INSERTION INSTRUCTIONS FOR AMENDMENT 6

BVPS-2 ER-OLS

FIGURE E290.7-1
 TRANSFORMER AND OUTDOOR
 LOUDSPEAKER LOCATIONS
 BEAVER VALLEY POWER STATION-UNIT 2
 ENVIRONMENTAL REPORT
 OPERATING LICENSE STAGE

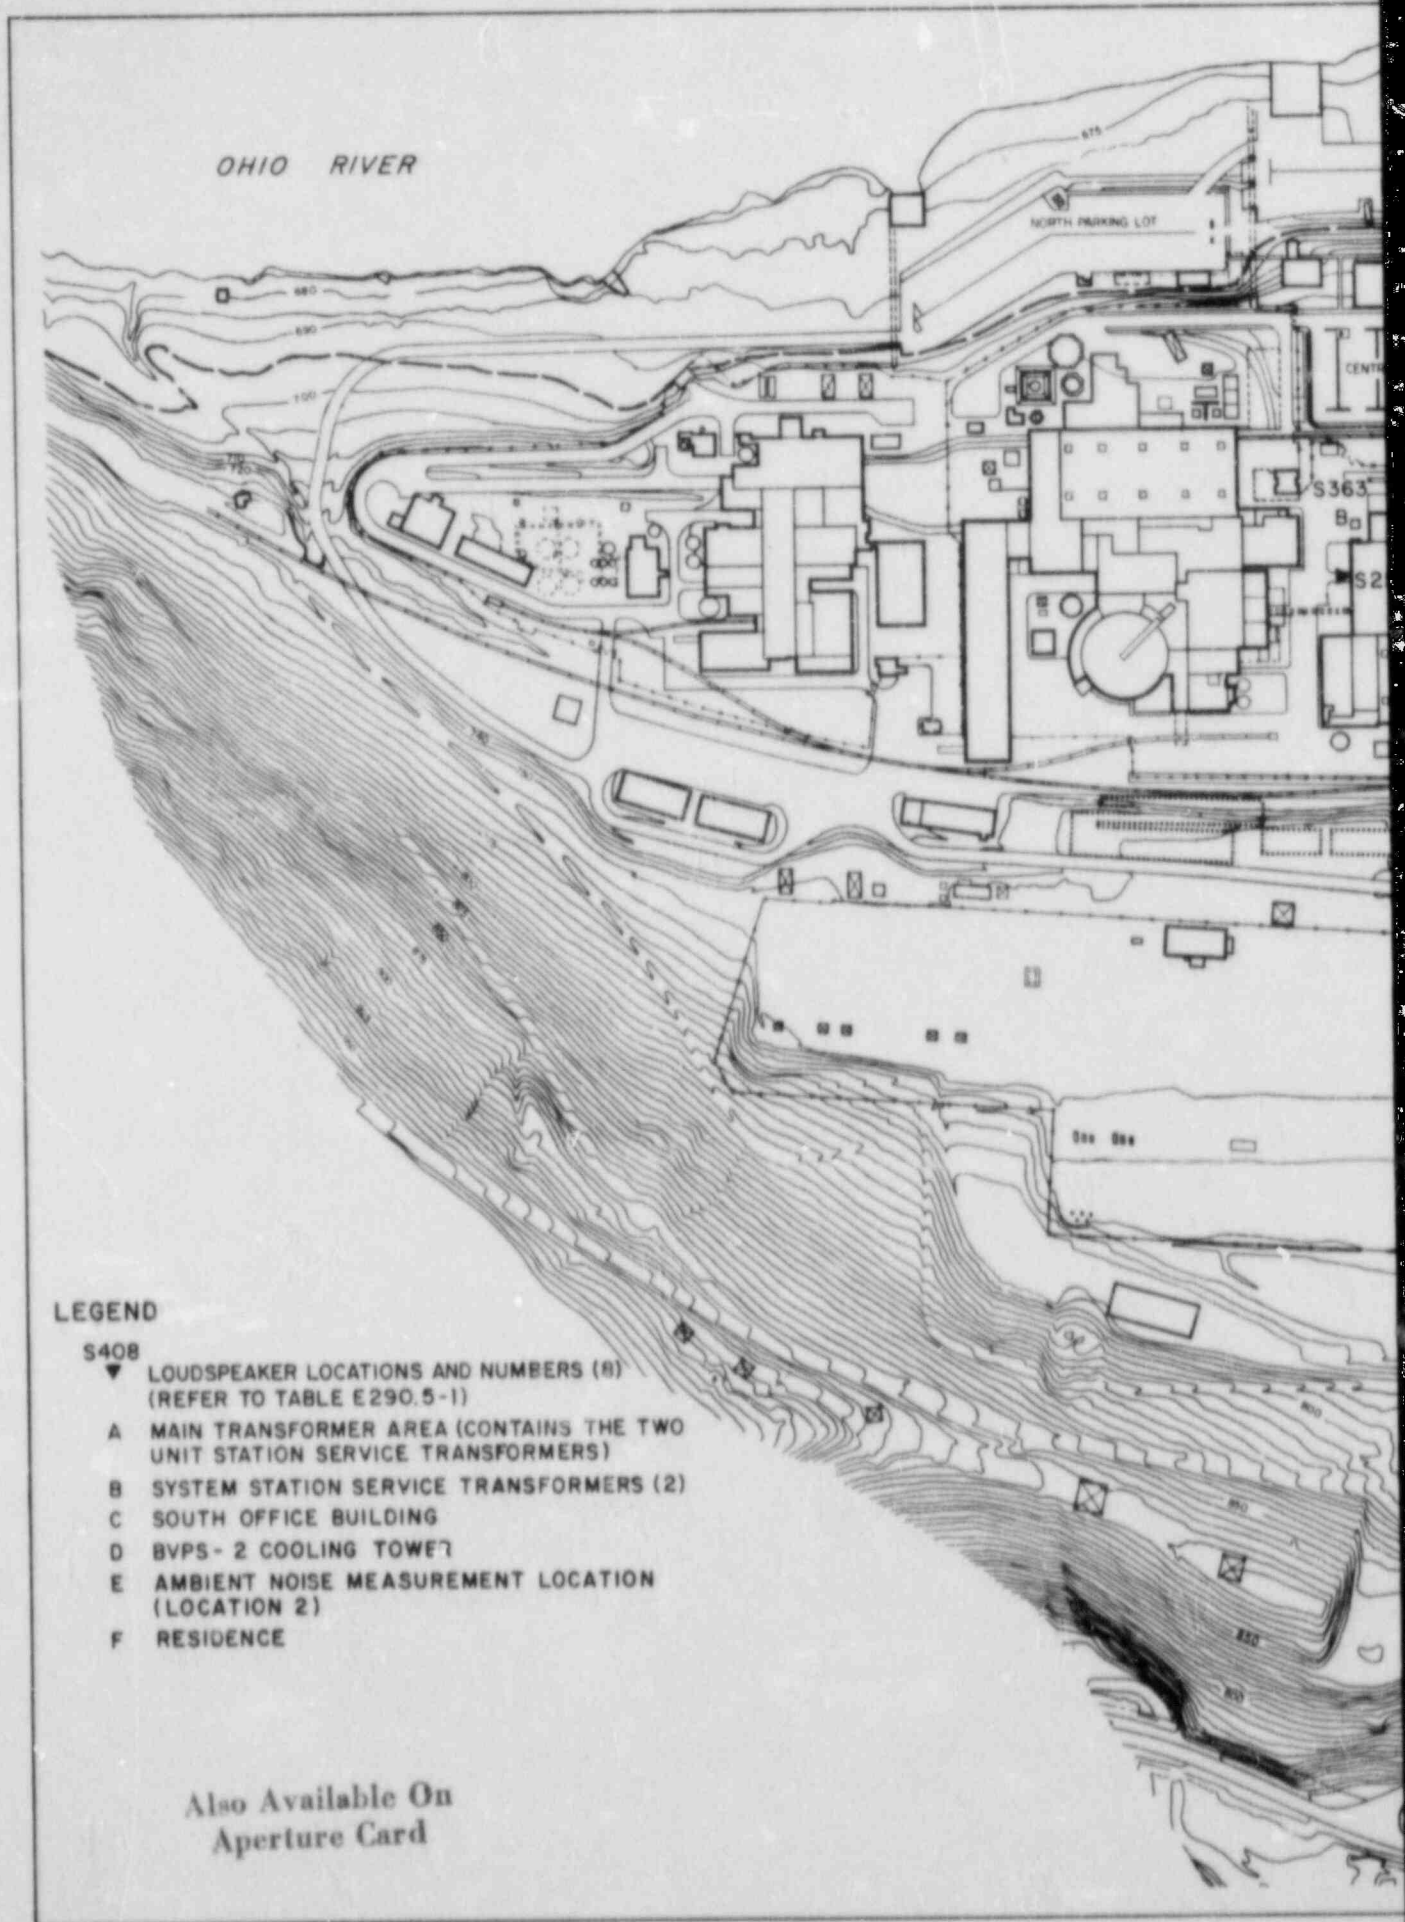
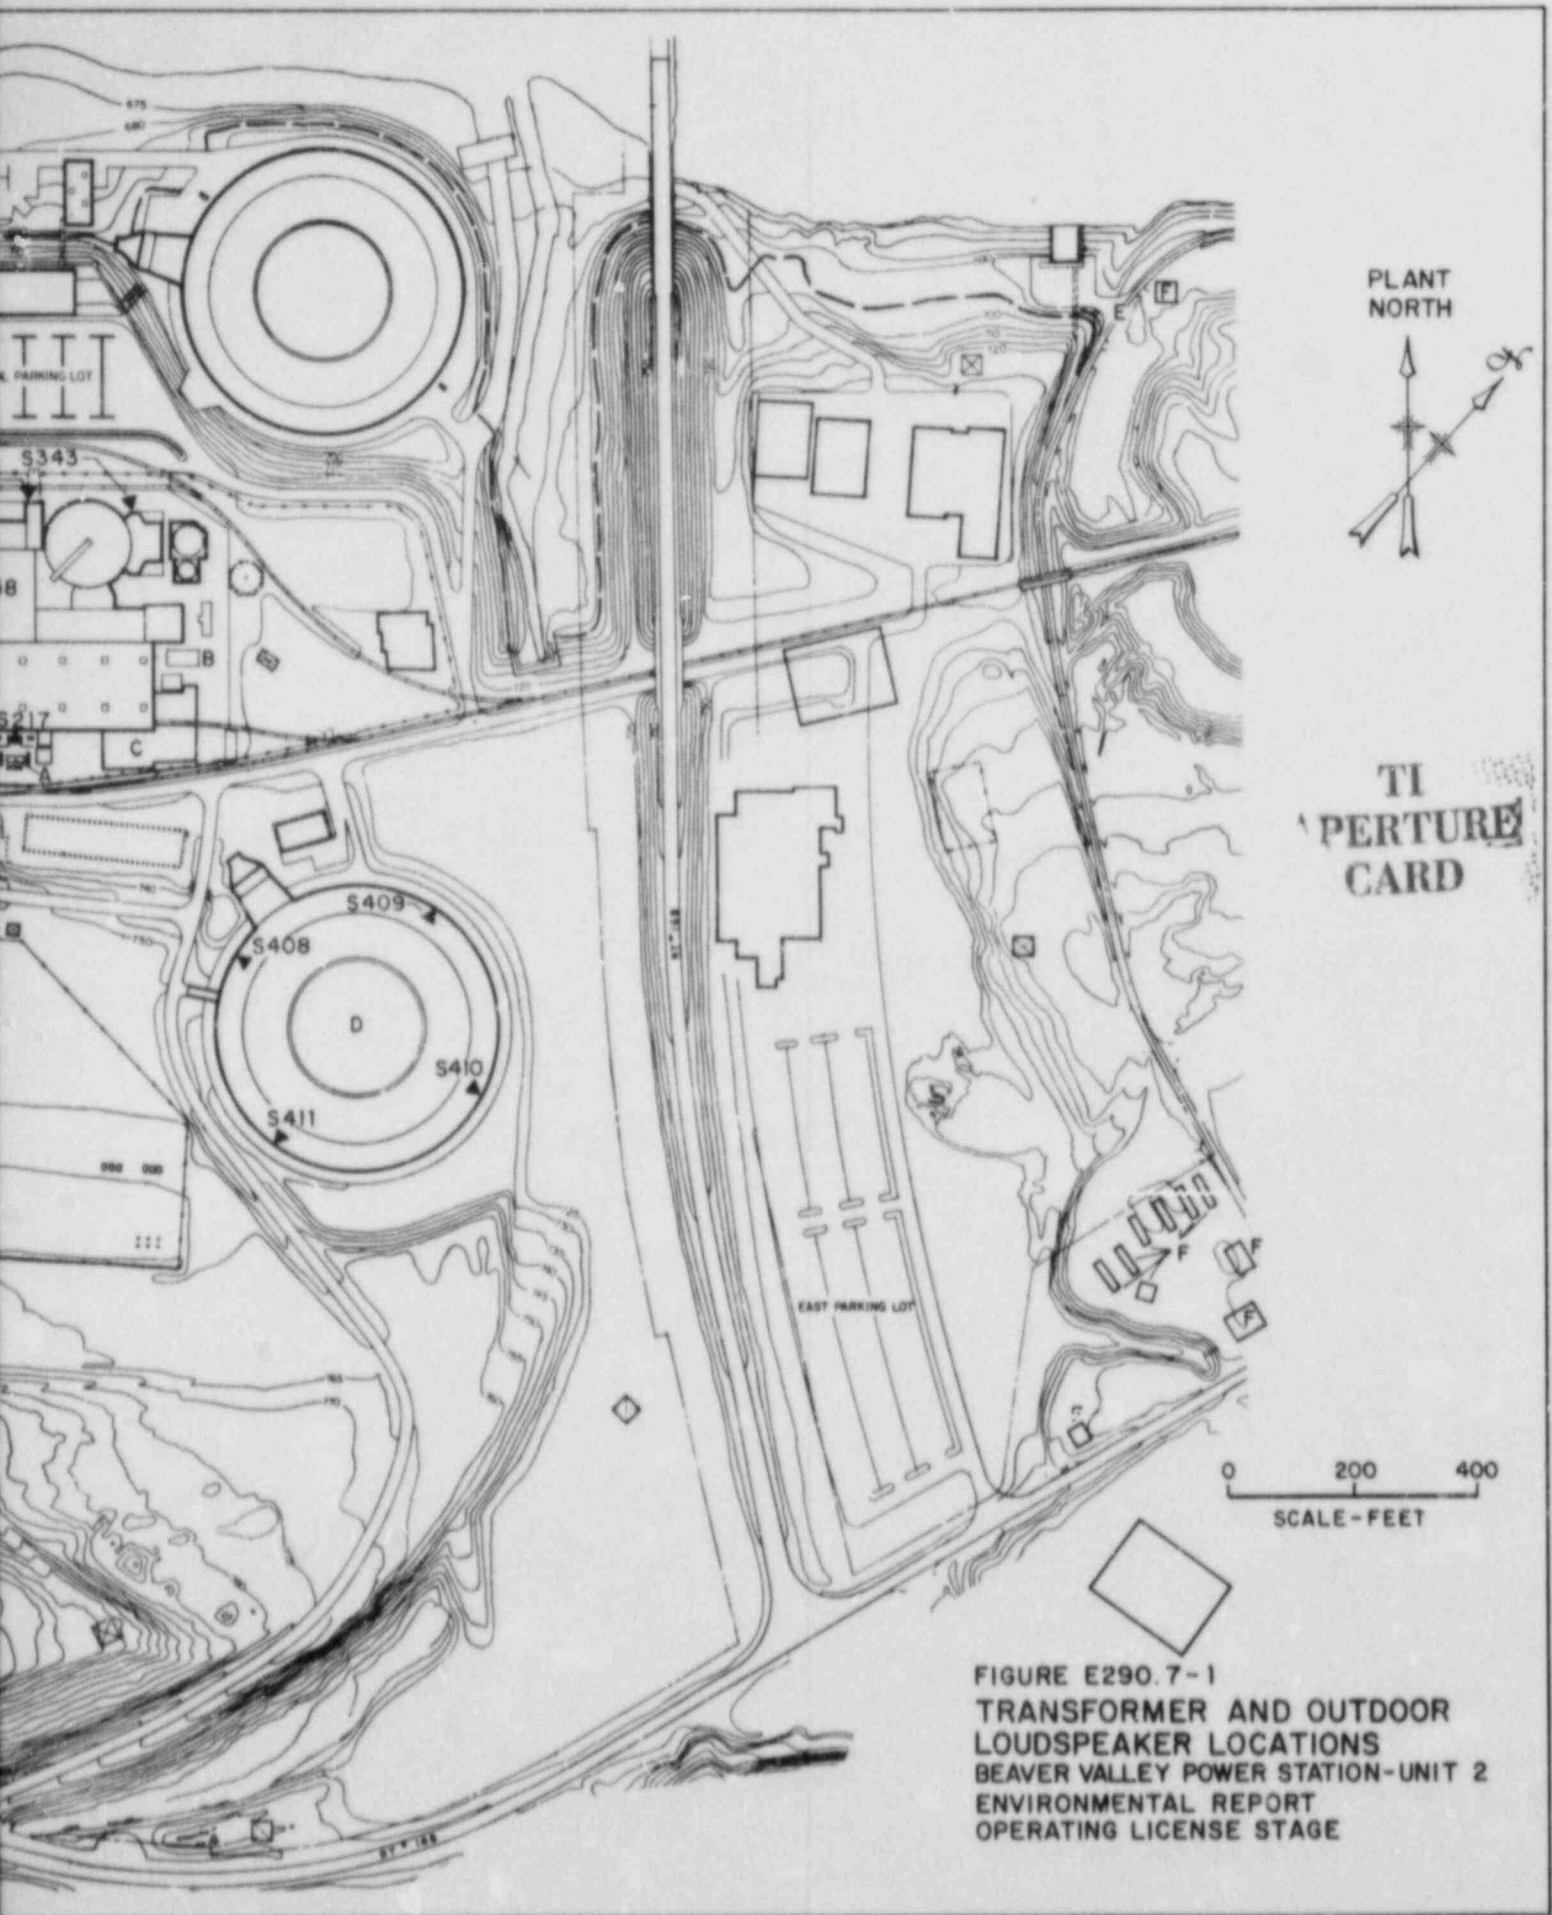
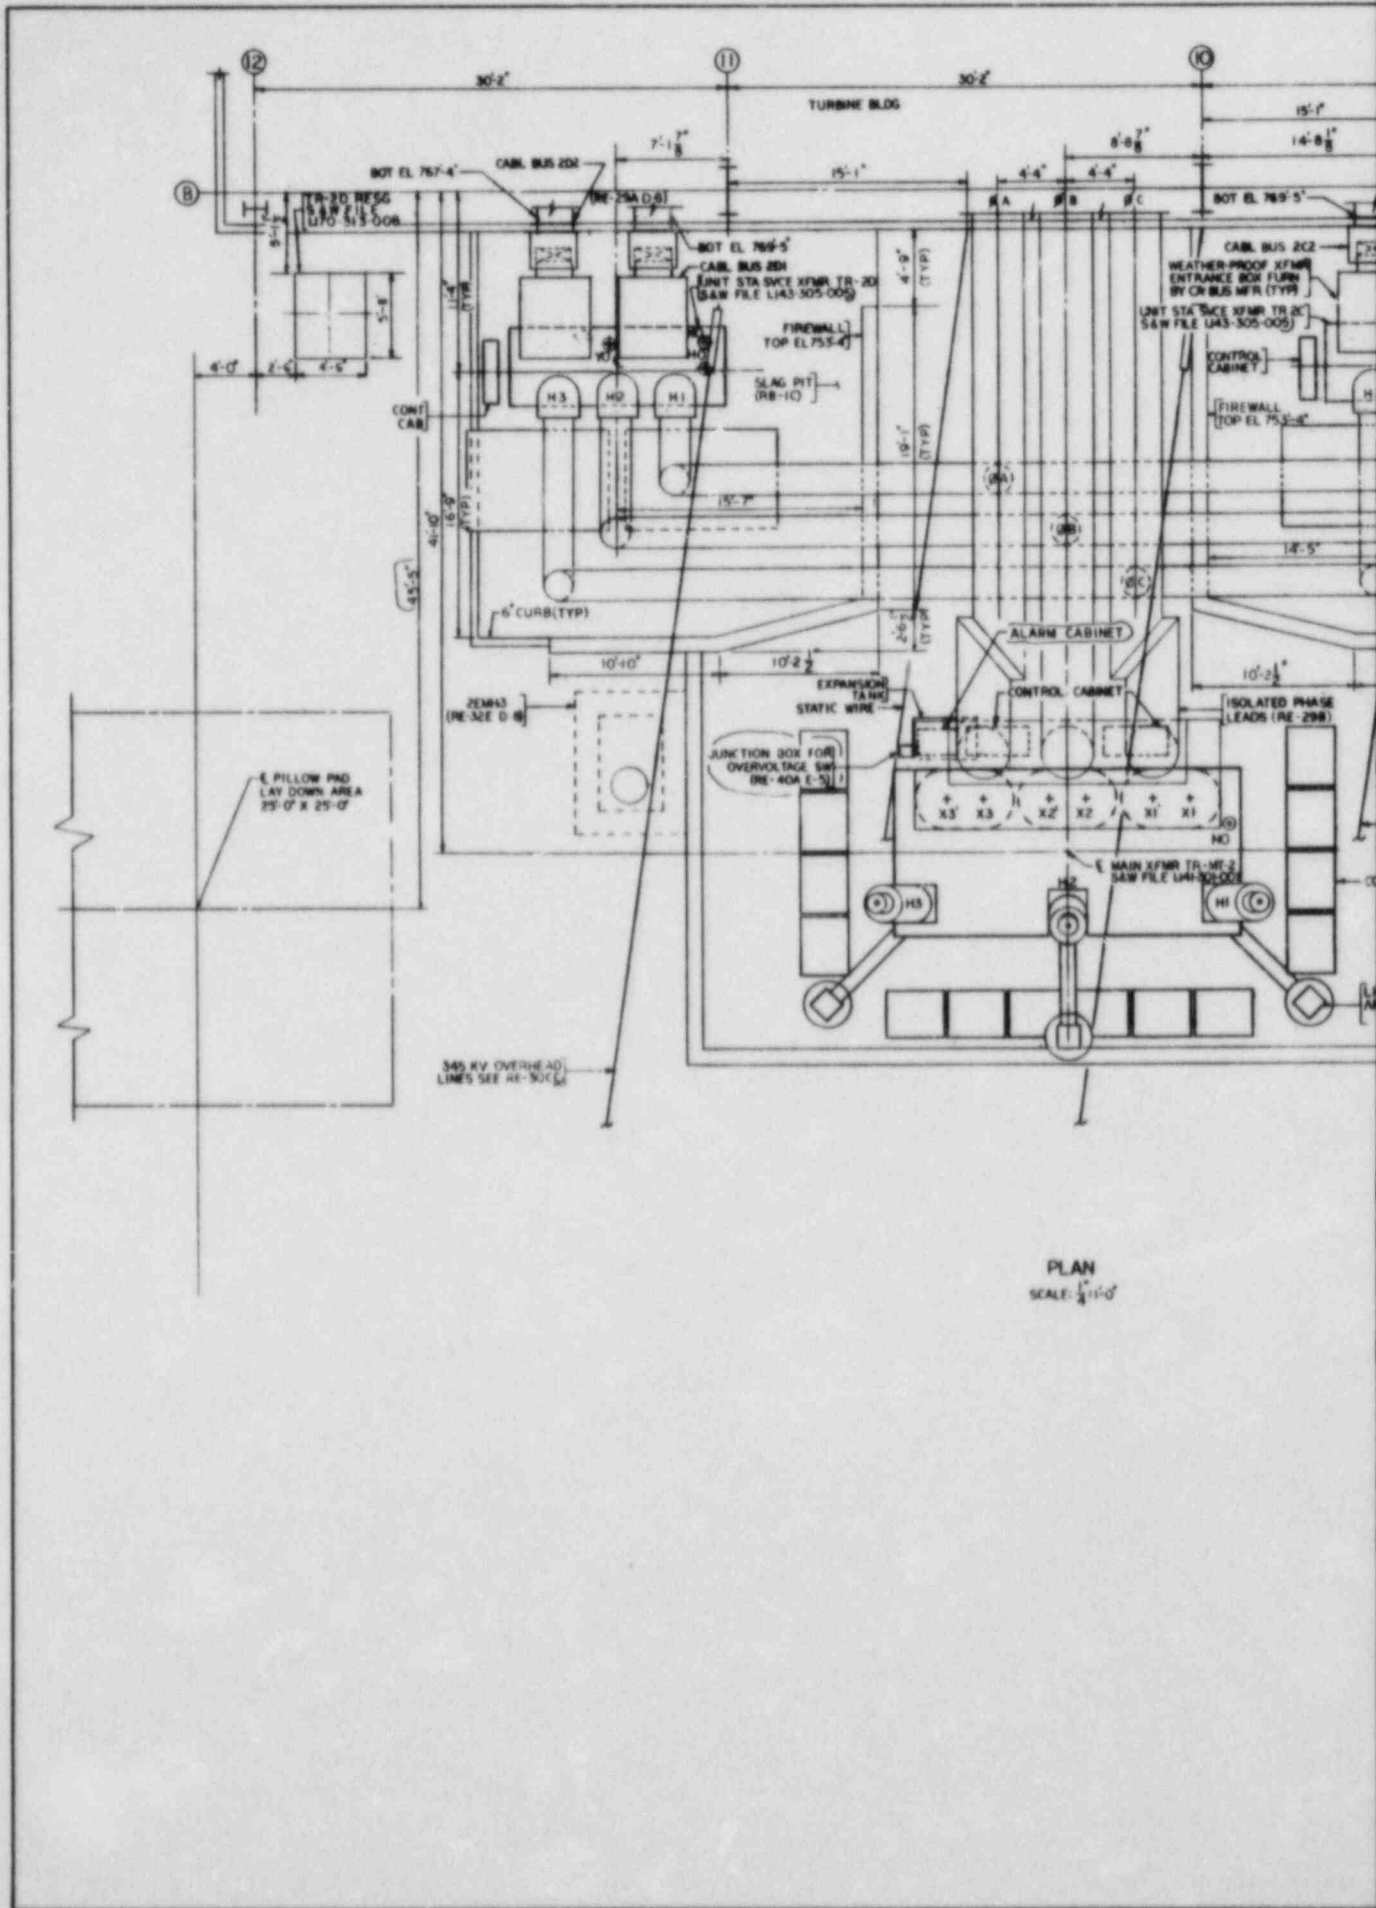
Provide a map of the site containing the locations of the loudspeakers that would impact the trailer park on Rt. 168 (home of George White) during plant operation. Provide coordinates (including elevation) of the loudspeakers and their major axis of directivity.

Provide a scaled plan view sketch of the location of the transformers (main and auxiliary) and their firewalls. Mark on the drawing the distances between transformers and firewalls. Note also the height of the firewalls and height of the transformers. Construction layout drawings for the region around the main and auxiliary transformers are an acceptable alternative to the sketches since the detailed drawings should provide the same information.

Table E290.5-1 lists data including plant coordinates, elevations, and directions of aim for external loudspeakers that will be used during operation of BVPS-2. The locations of the loudspeakers are shown on Figure E290.7-1.

Figure E290.7-1 contains a detailed plot plan of BVPS-2 with the locations of the main transformer, the unit station service transformers, and the system station service transformers clearly identified. The figure also shows the locations of the auxiliary boiler building and an adjacent building housing offices and work shops which have recently been added to the BVPS-2 construction plan. The combined barrier effects of the added auxiliary boiler building and the BVPS-2 cooling tower will provide additional reduction of the main transformer noise levels. In addition, the operation of the BVPS-2 cooling tower will also provide substantial masking of transformer noise. Figure E290.7-1 also shows the locations of the auxiliary boiler building and the BVPS-2 cooling tower relative to the location of the nearest resident at the intersection of Route 68 and Ferry Hill Road.
